Amendment 1 to Council Bill No. 79-2016

Amendment No. 1

(This amendment provides a more accurate map of the boundary of the Tiber Branch Watershed, clarifies that the map is illustrative, includes reference to rainfall data from NRCS and other government scientific agencies, and provides that the change to § 18.903 will sunset after the Design Manual is updated.)

EXHIBIT A

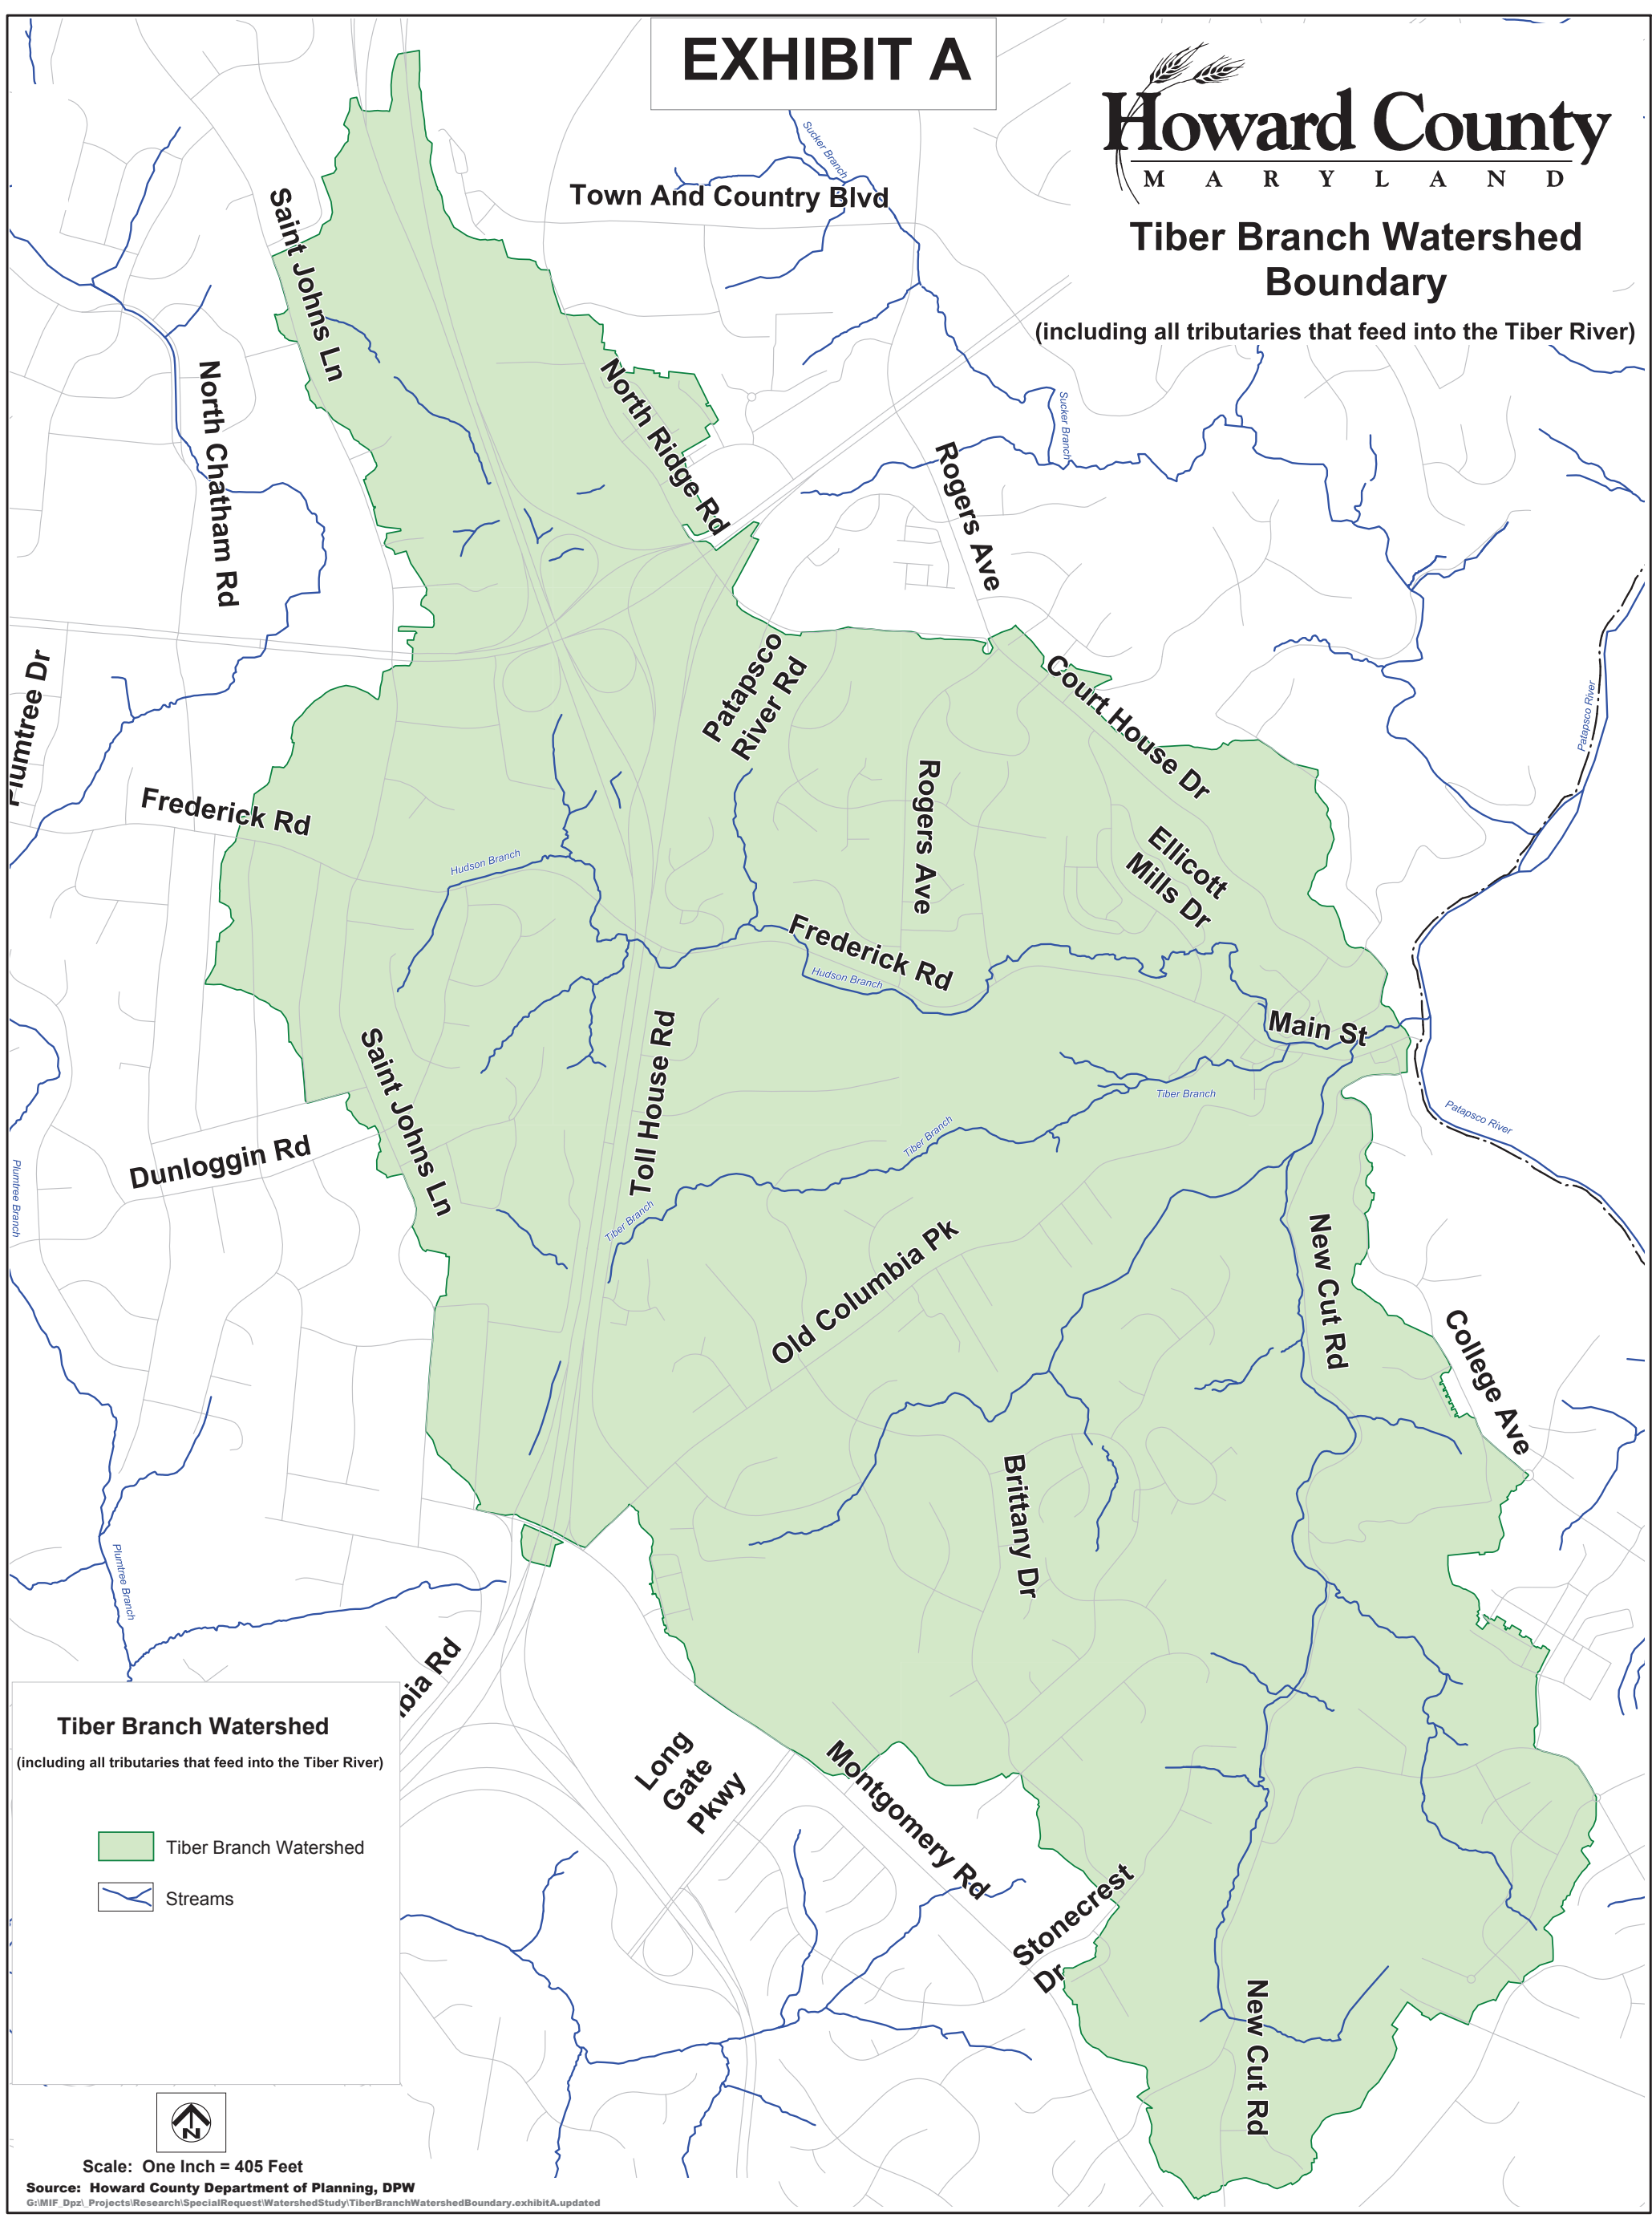
1 Remove Exhibit A that is attached to the Bill and substitute the Exhibit A that is attached to this
2 Amendment.
